Sheet No. C0.0

Project Title:
EAST TOWN CROSSING PHASE 1

Project No.
2230752
Issue Set & Date:
PERMIT SUBMITTAL
11/20/2023

Sheet No.
C3.1

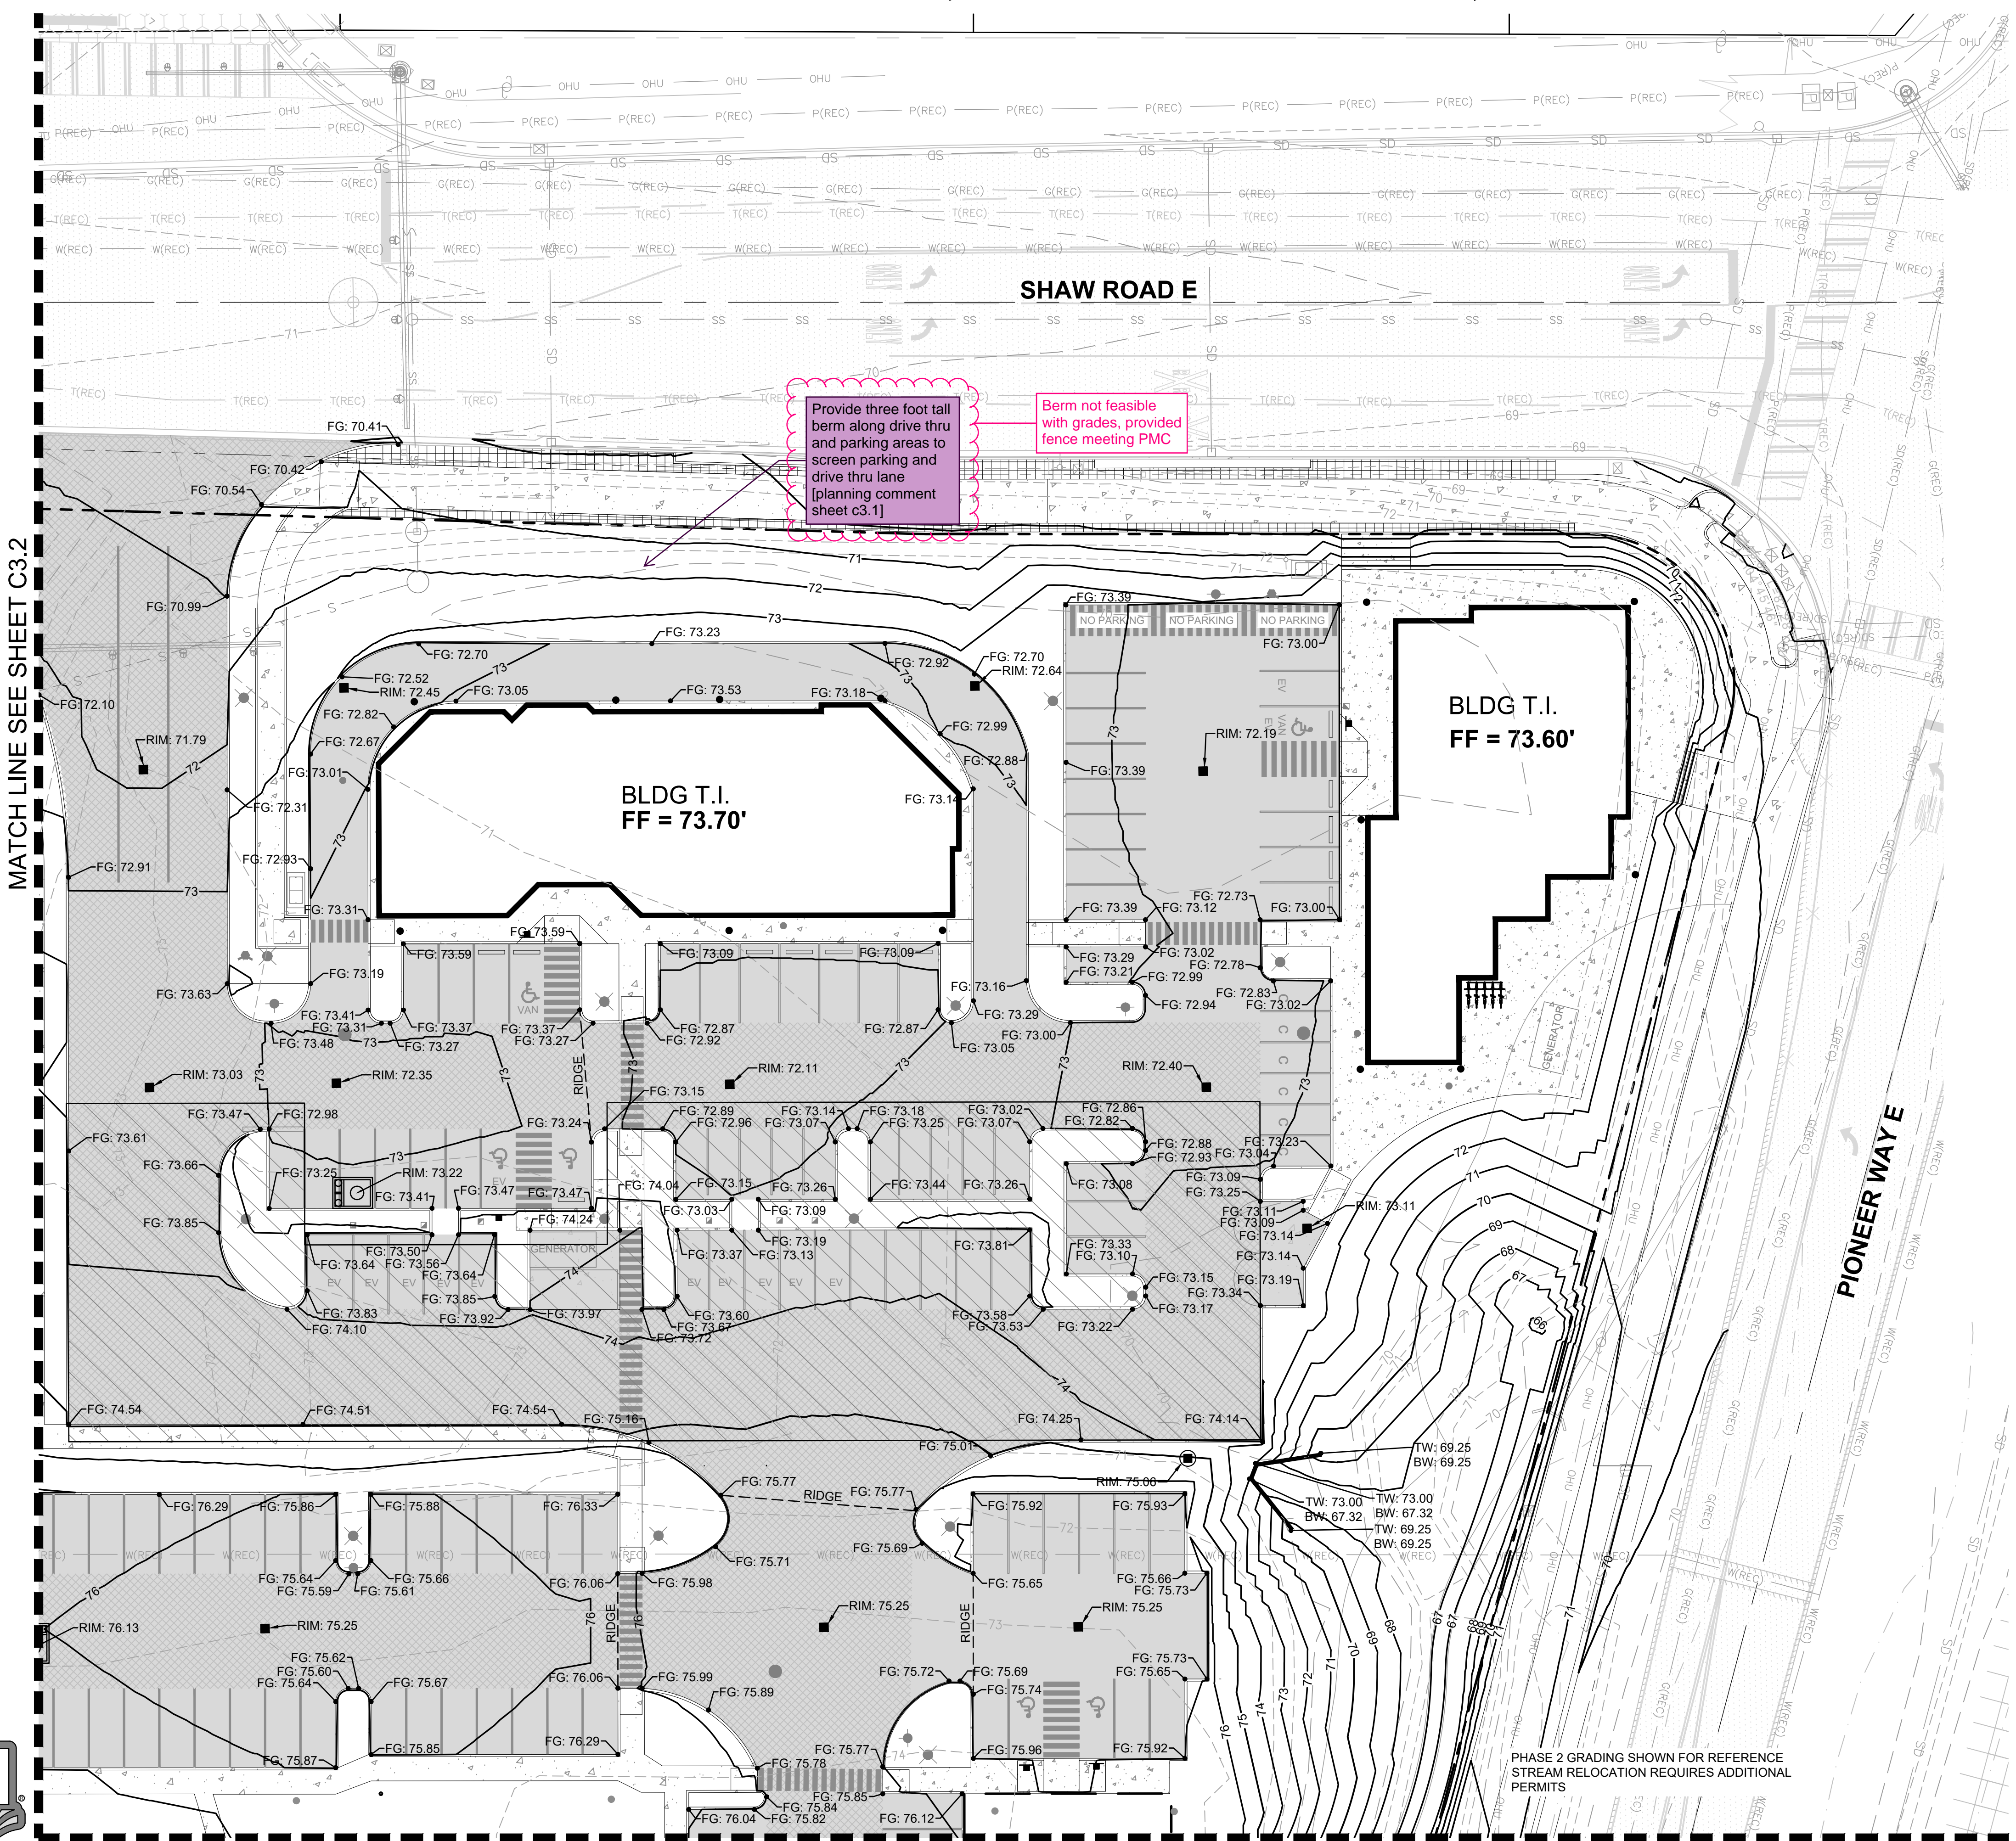
Delineate the regulated floodplain per the LOMR, Effective September 8, 2022. (Plans SH C3.1; Pg 10 of 63)

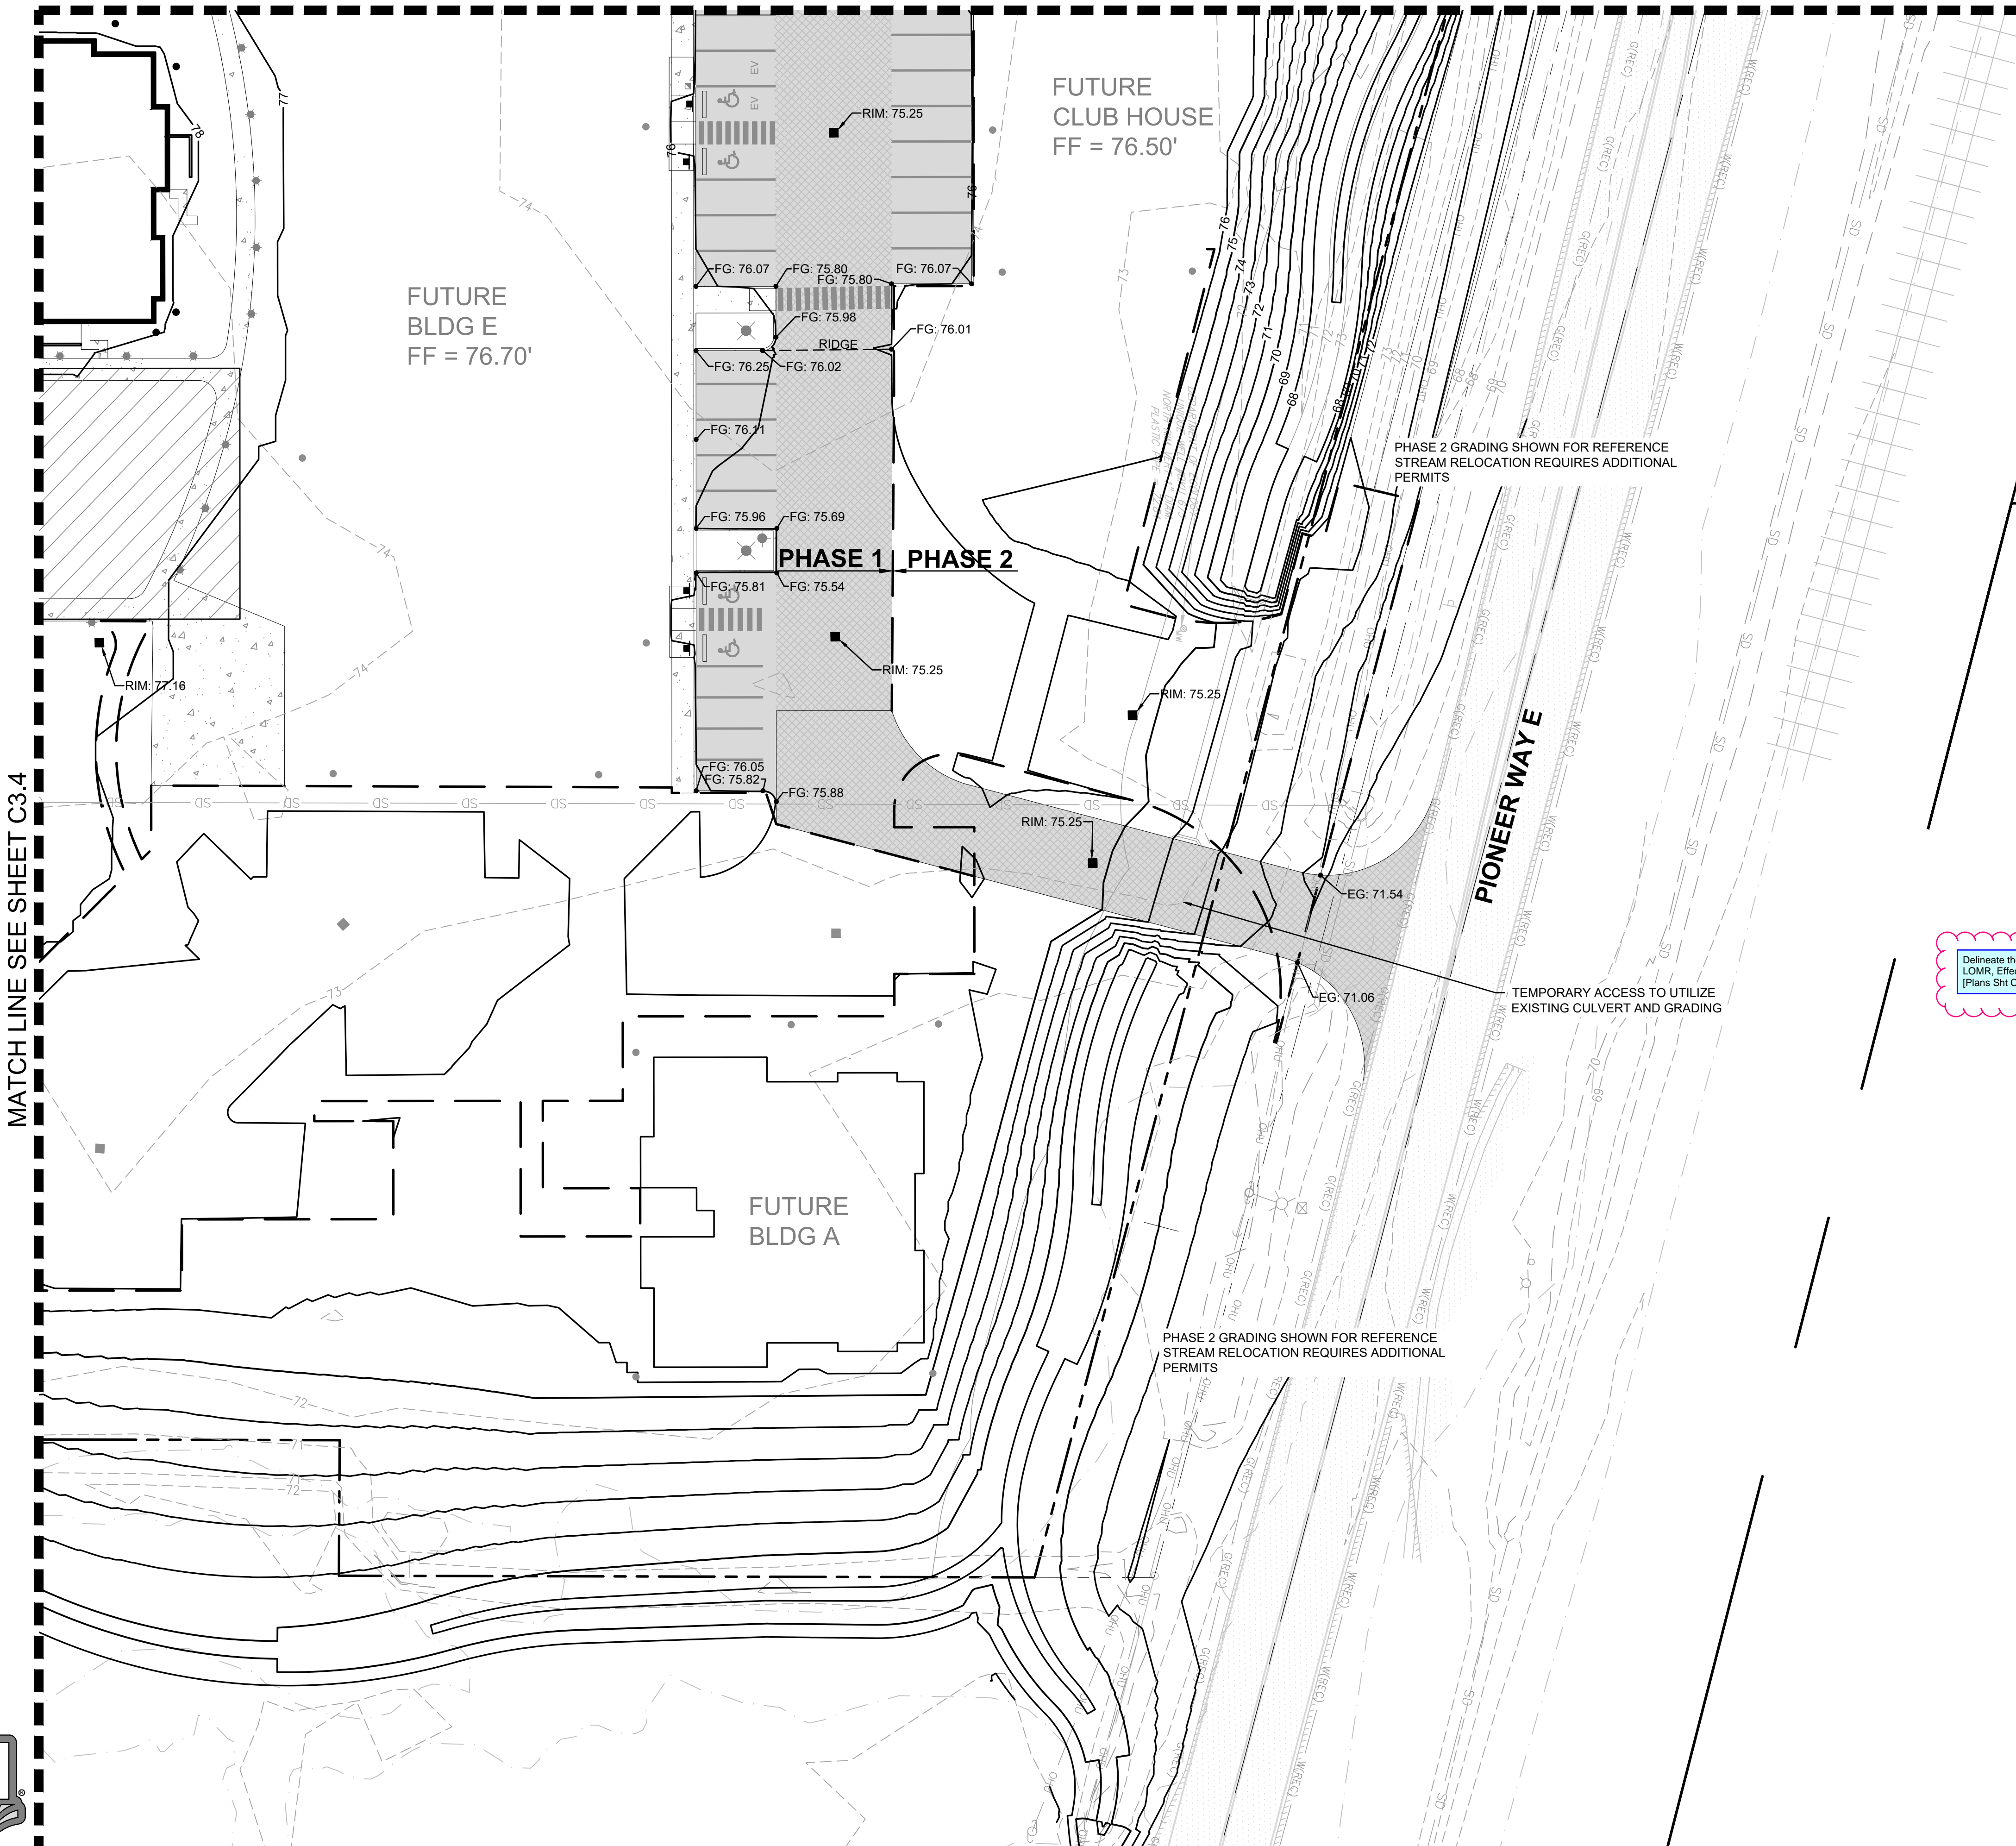
Delineate the regulated floodplain per the LOMR, Effective September 6, 2022. [Plan Sht C3.3, Pg 12 of 63]

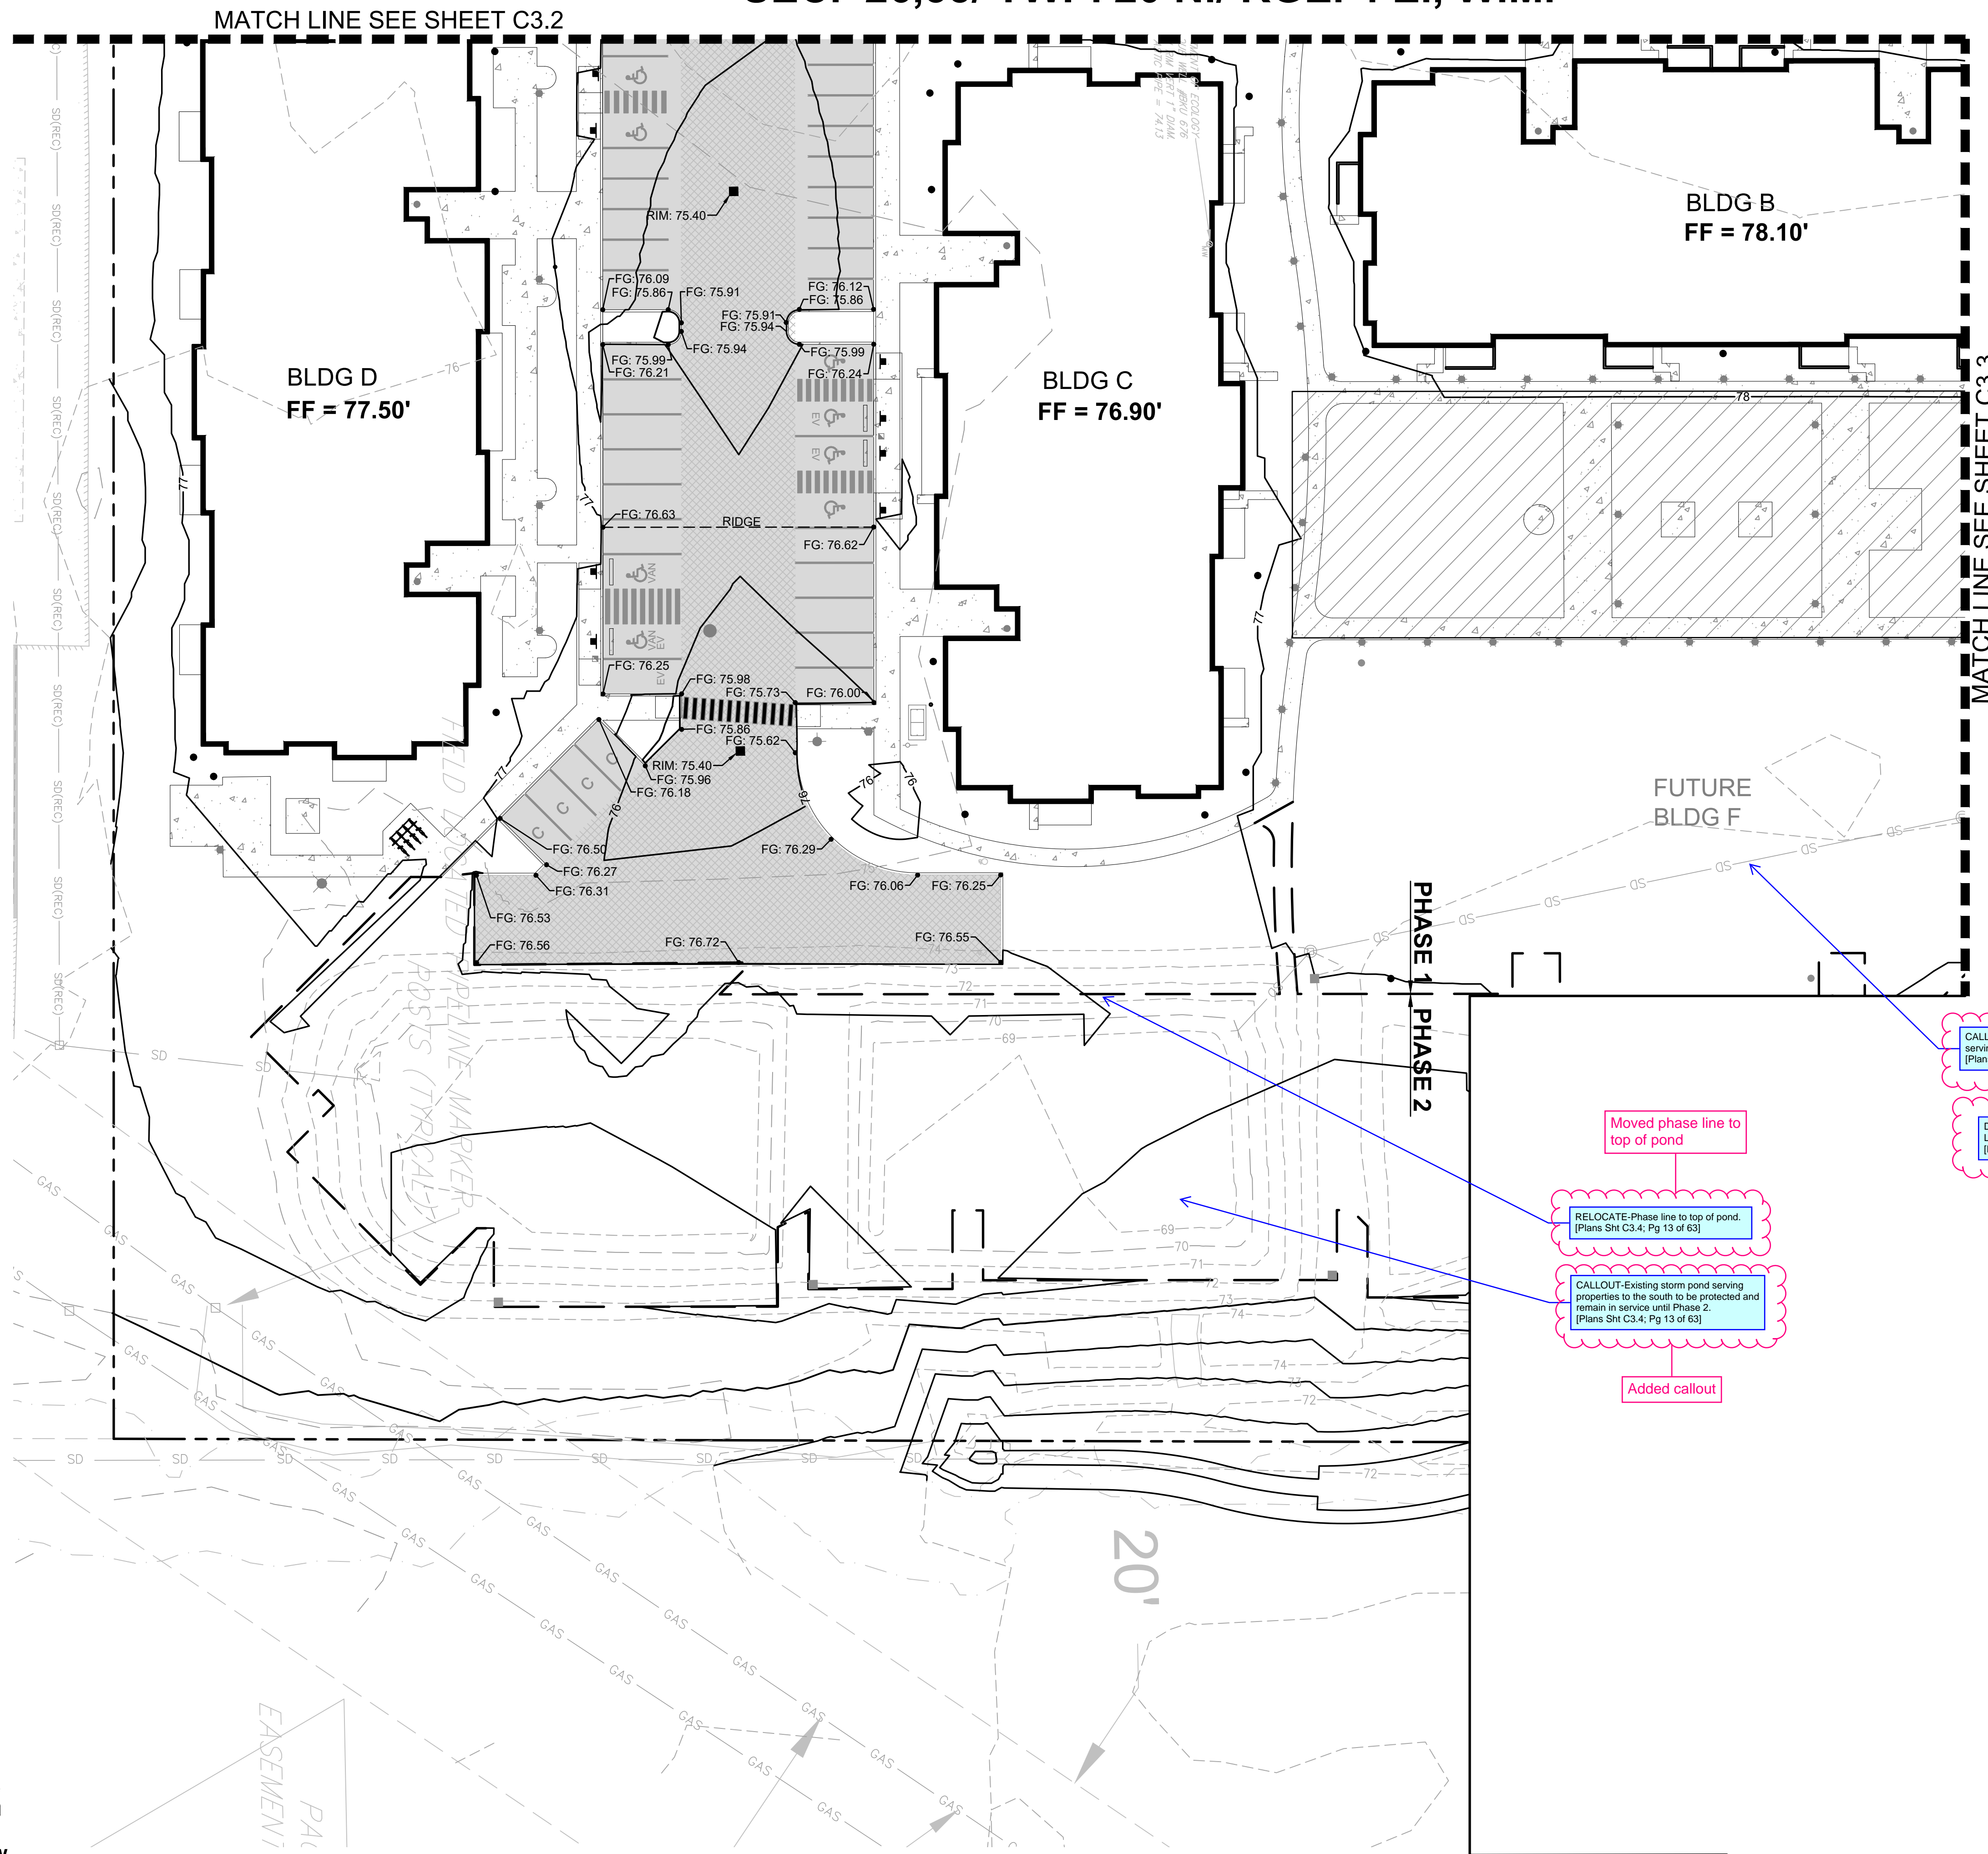
CALLOUT to protect existing storm drain serving properties to the south.
[Plans Sht C3.4; Pg 13 of 63]

Delineate the regulated floodplain per the LOMR, Effective September 8, 2022.
[Plans Sht C3.4; Pg 13 of 63]

RELOCATE-Phase line to top of pond.
[Plans Sht C3.4; Pg 13 of 63]

CALLOUT-Existing storm pond serving properties to the south to be protected and remain in service until Phase 2.
[Plans Sht C3.4; Pg 13 of 63]
